**PLANNING COMMISSION REPORT**  
**Regular Agenda -Public Hearing Item**

**ITEM NO. 5B: PRELIMINARY DEVELOPMENT PLAN FOR ALVAMAR; 1800, 1809, 2021 CROSSGATE DR (SLD)**

**PDP-16-00052:** Consider a Revised Preliminary Development Plan for Alvamar PD, Lots 1, 2a, 2b, and 3, located at 1800, 1809, & 2021 Crossgate Dr. Submitted by Paul Werner Architects, for Eagle 1968, LC, (contract purchaser). Alvamar Inc. is the property owner of record.

ALVAMAR LOT 1, 2A, 2B & 3  
PRELIMINARY  
DEVELOPMENT PLAN

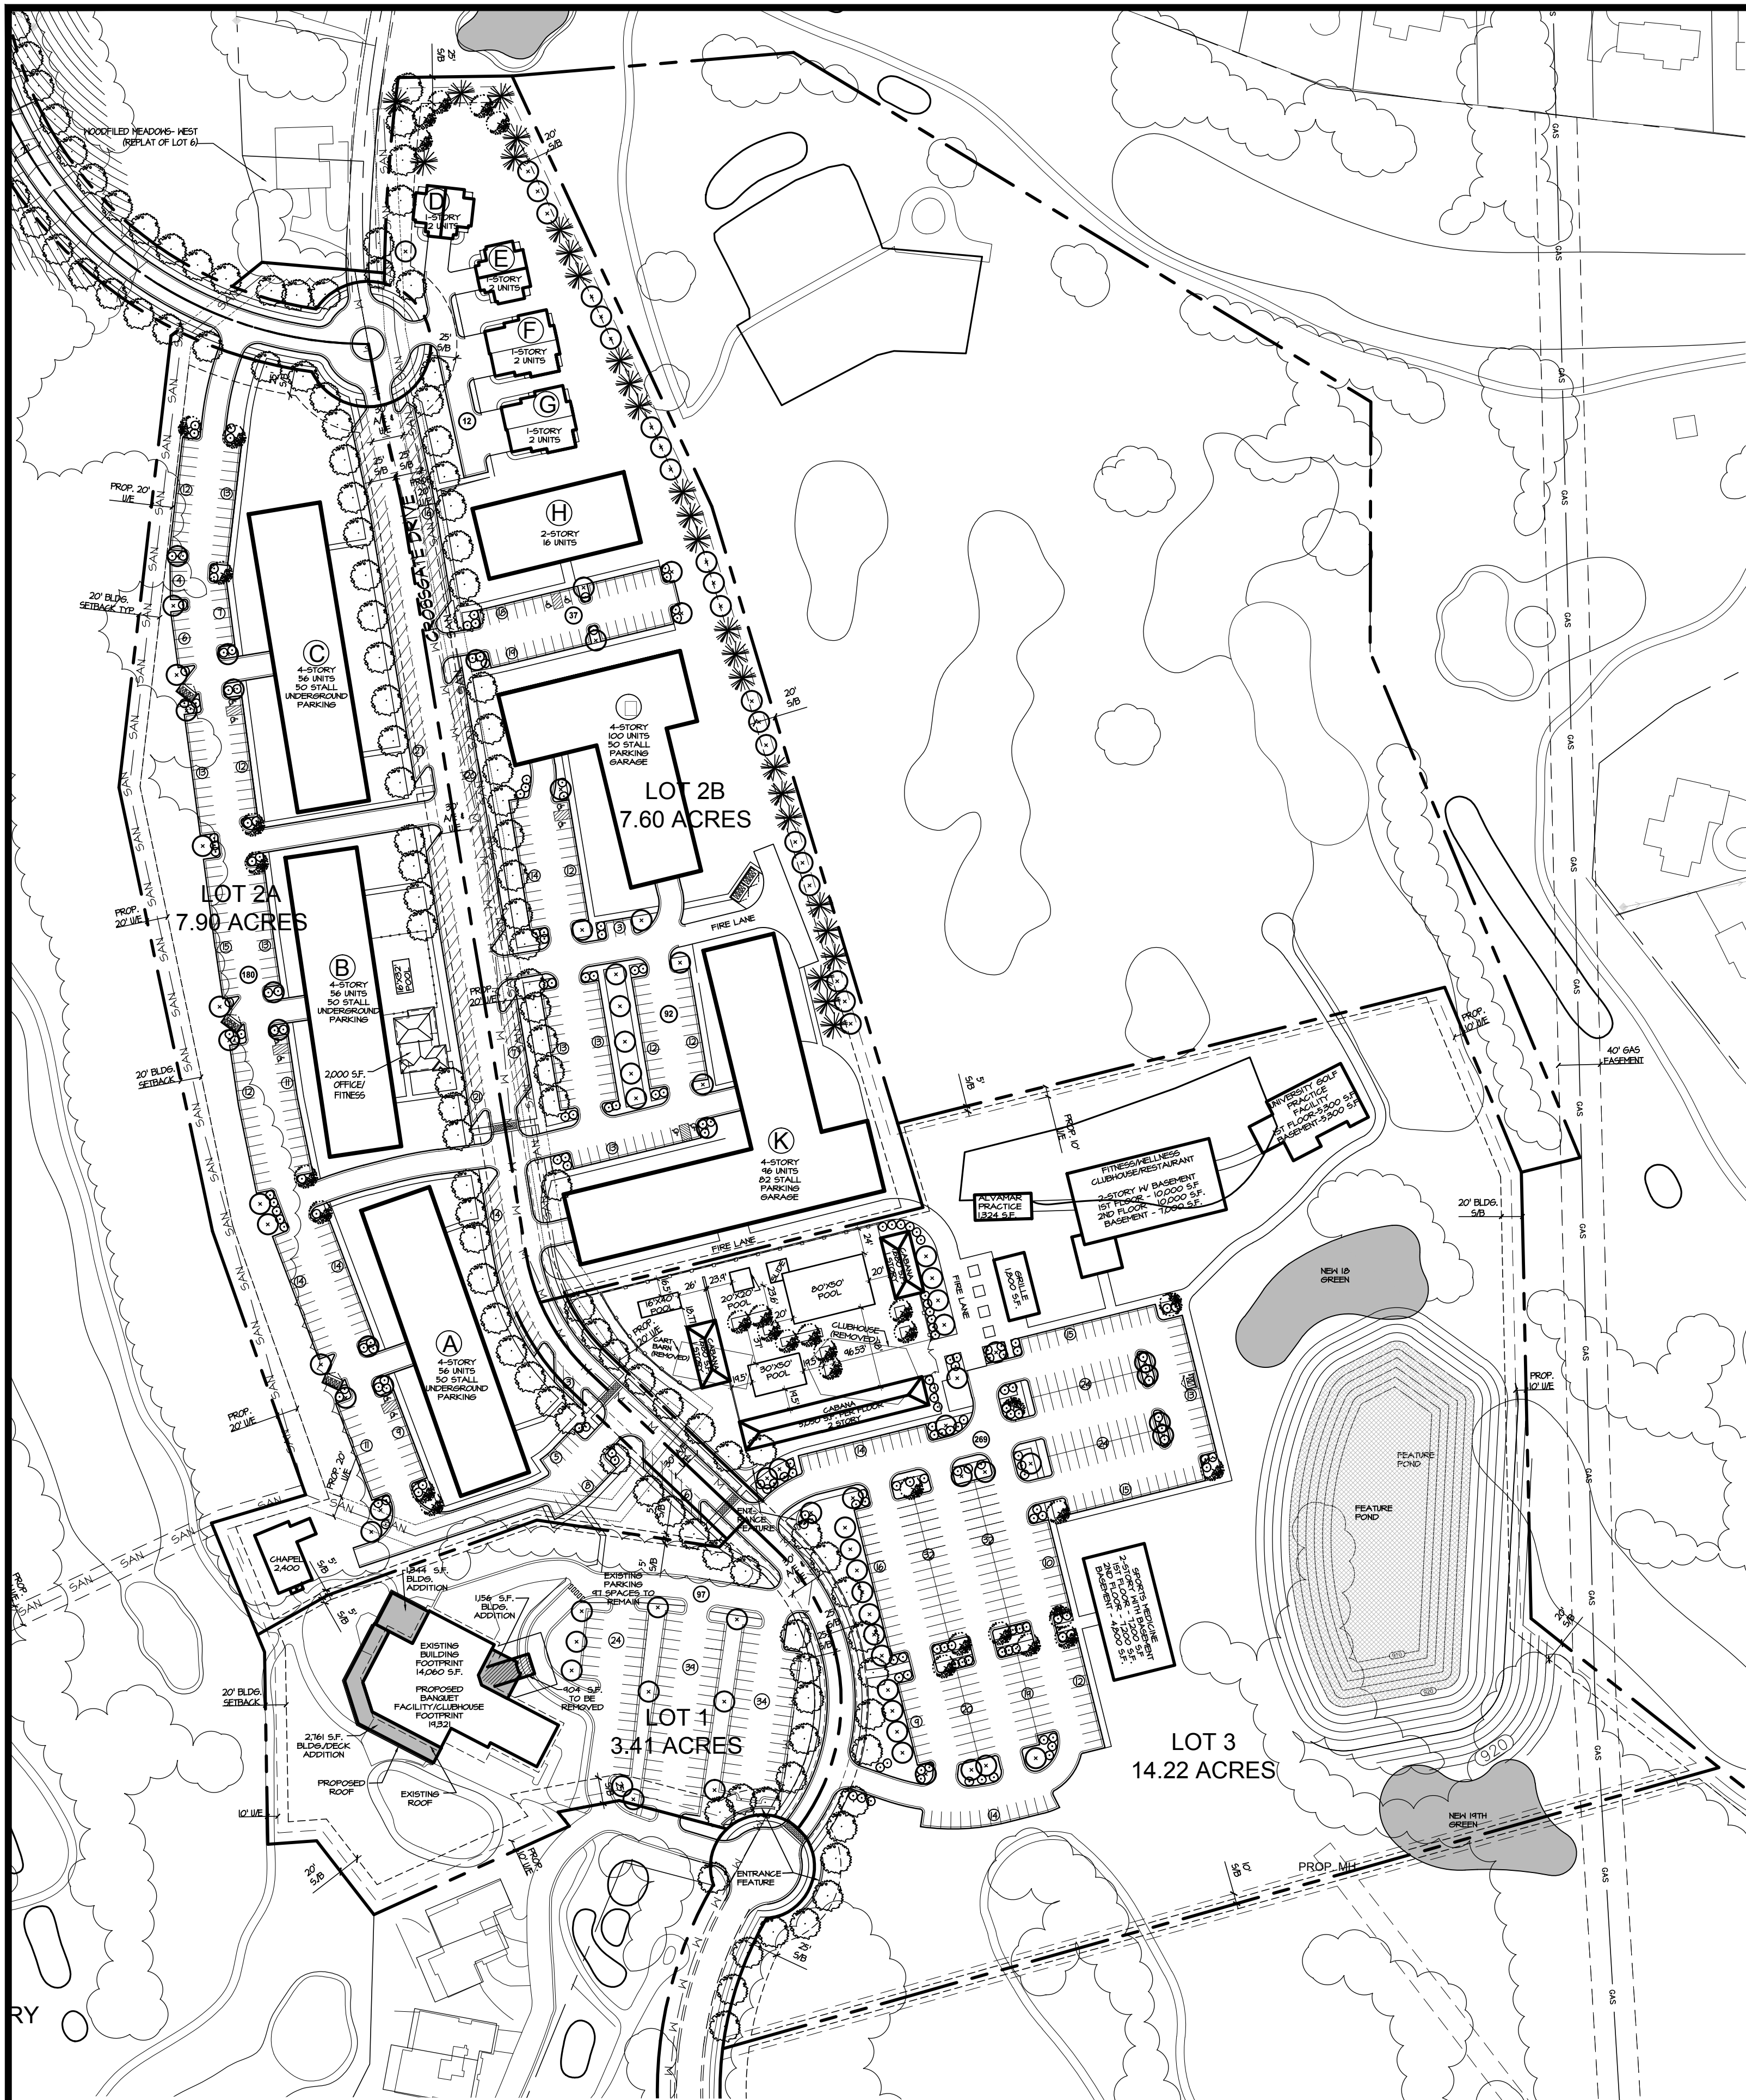
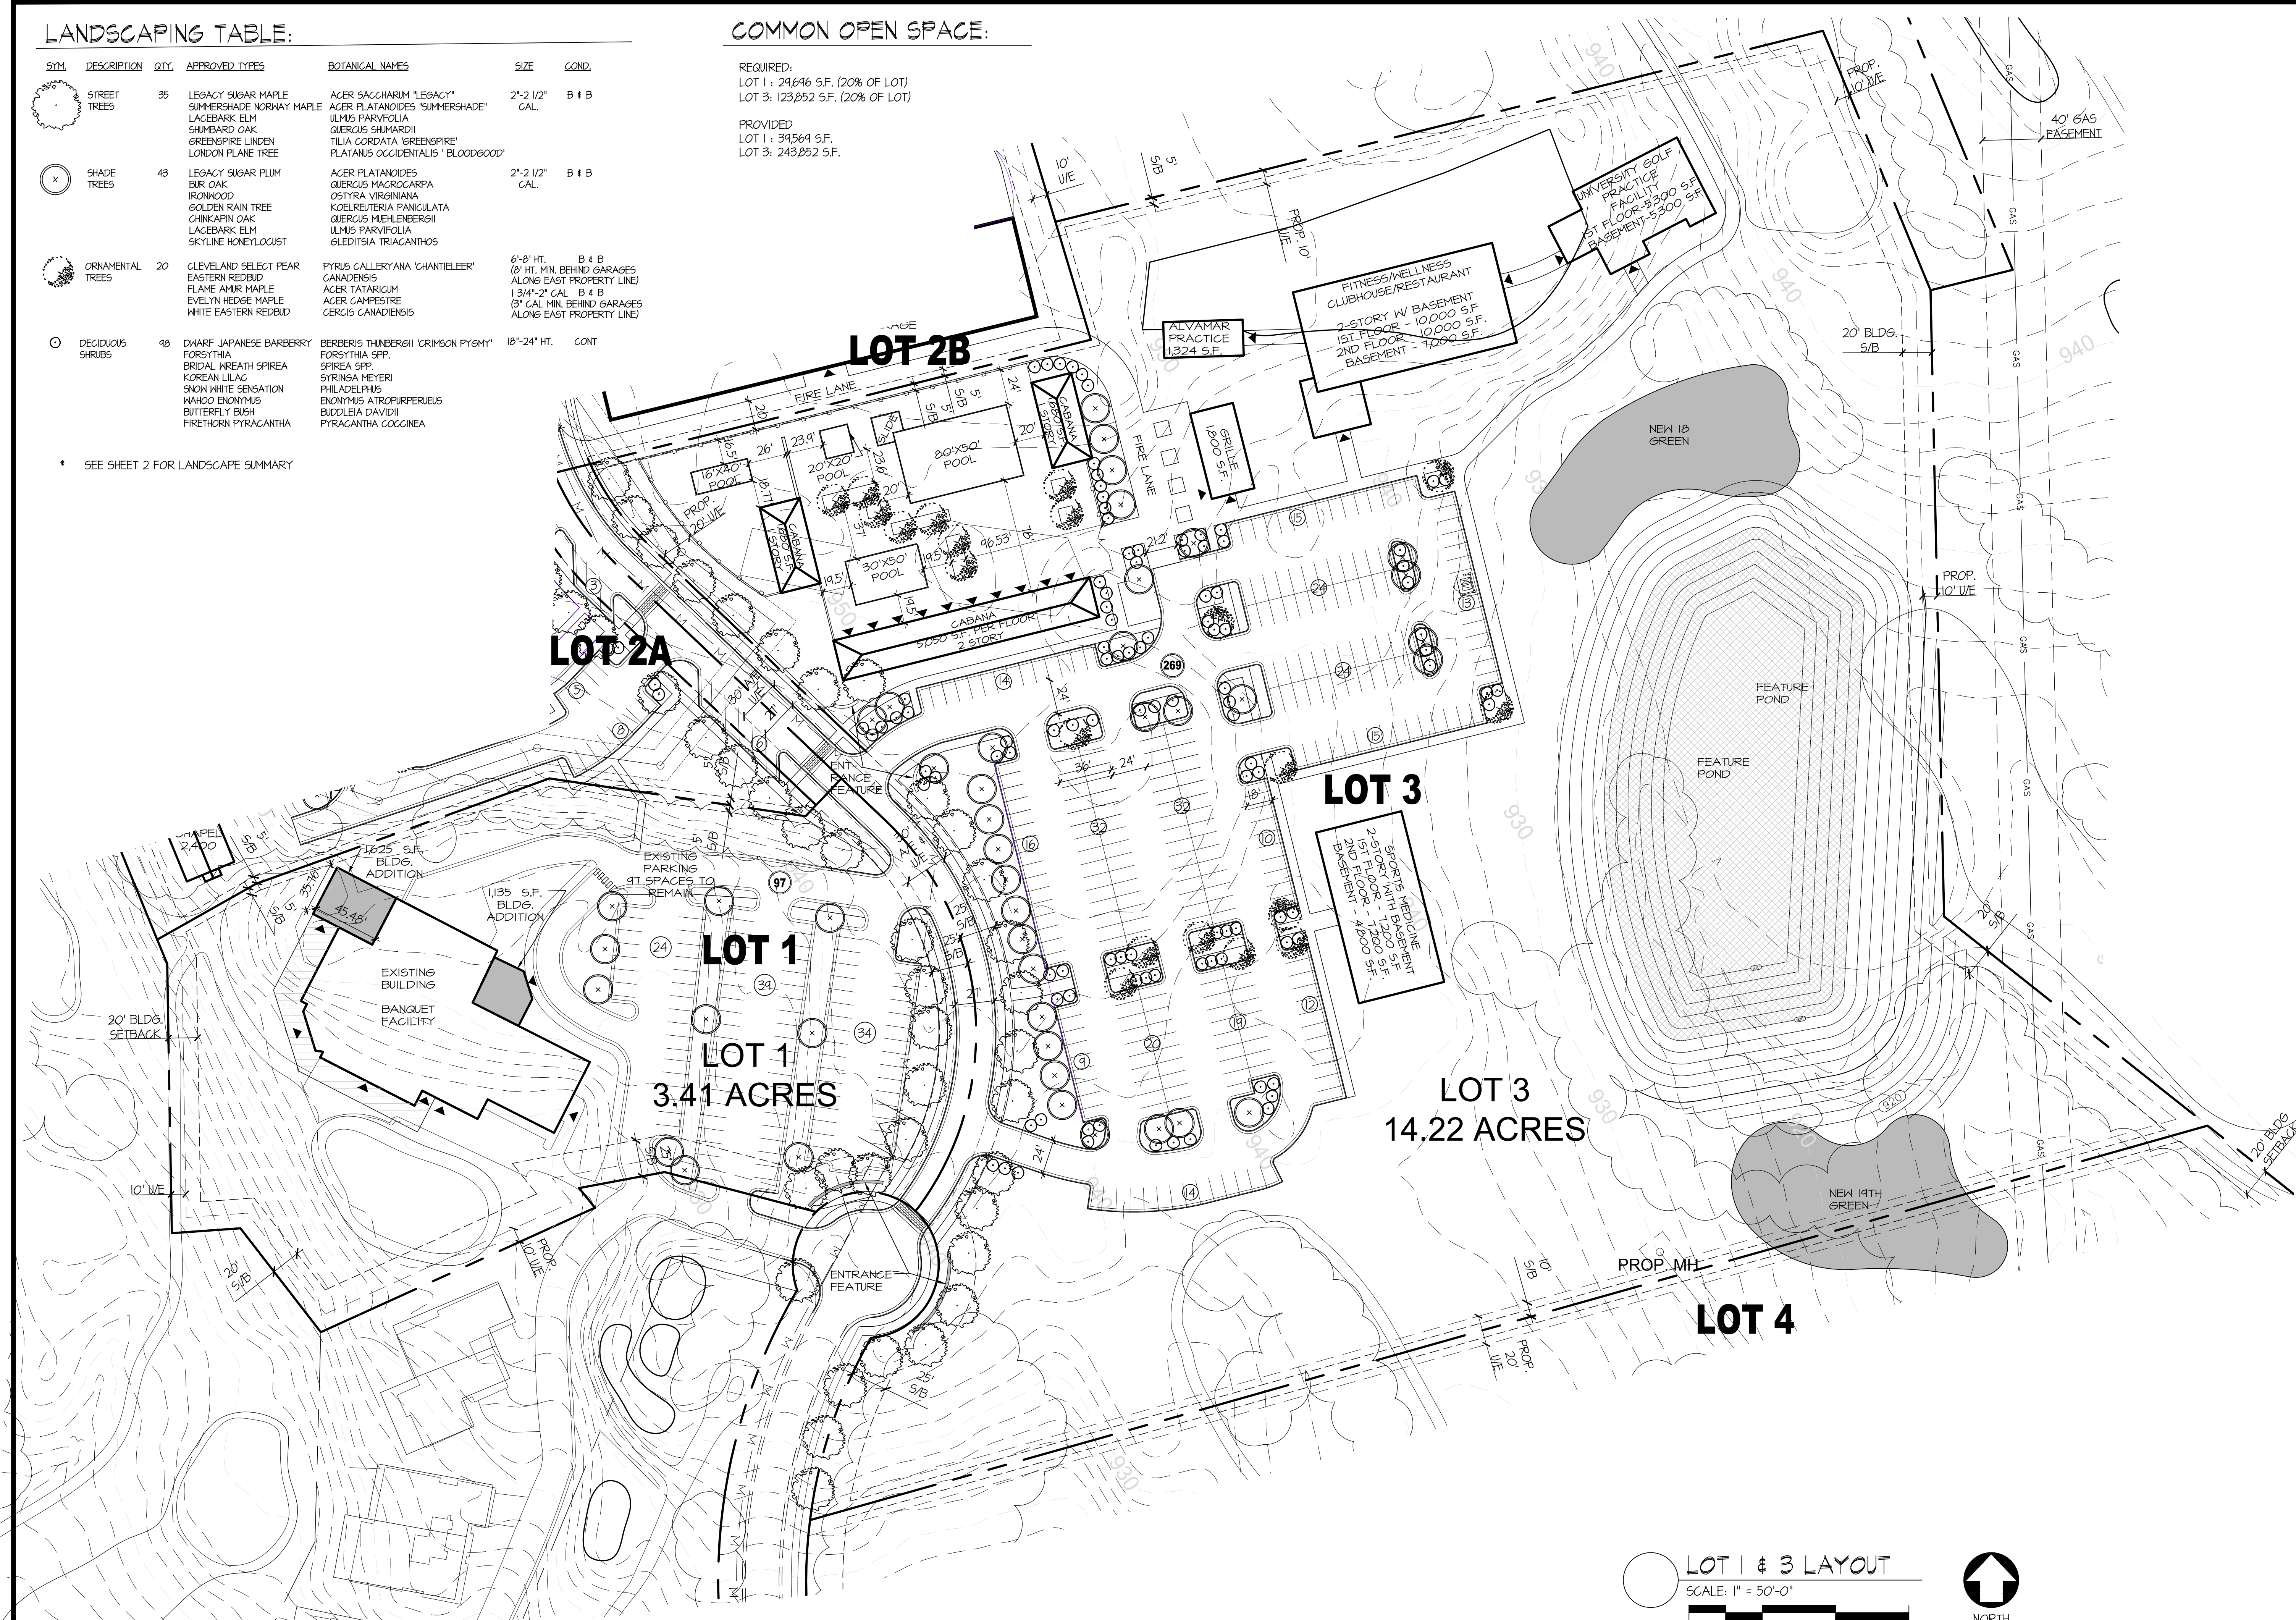
- a. Revise the width of the 30' access/utility easement for the "private street segment" to include sidewalks on both sides of the private street.
  - b. Revise drawing to remove all references to "Sports Medicine".

- c. Revise drawing to provide parking for the chapel use.
  - d. Revise parking table to show the required parking for the Banquet Facility based on the standard for *Event Center, Large* at 1 space per 4 occupancy. This correct parking requirement should show 103 spaces.

- e. Revise the parking table per this staff report to show the total required off-street parking.

- The Event Center requires a total of 103 parking spaces.
- The chapel use requires a total of 25 parking spaces. These spaces were not accounted for by the applicant in the proposed plan.

One additional non-residential use, new to this plan, is also not included in the parking summary. The proposed plan includes a 2,400 SF chapel located on Lot 2A. Parking for *Religious Assembly* is calculated at 1 per 4 seats in the sanctuary or principal worship or assembly space.

The plan shows 114 spaces provided along the private street, however some of these spaces are required to support the residential use. All total, parking for the non-residential uses of this development is short 41 spaces of the Development Code requirements.

**Sidewalks:** Pedestrian connectivity is a key element within this development. Sidewalks are required on both sides of the public and private street network. The plan as proposed shows a 30' Access and Utility Easement that incorporates the private street section. The City Engineer recommends that the easement include the sidewalks. This would increase the easement to approximately 60'. The easement does not impact the lot line or building setback. This easement will also be considered with the Final Plat.
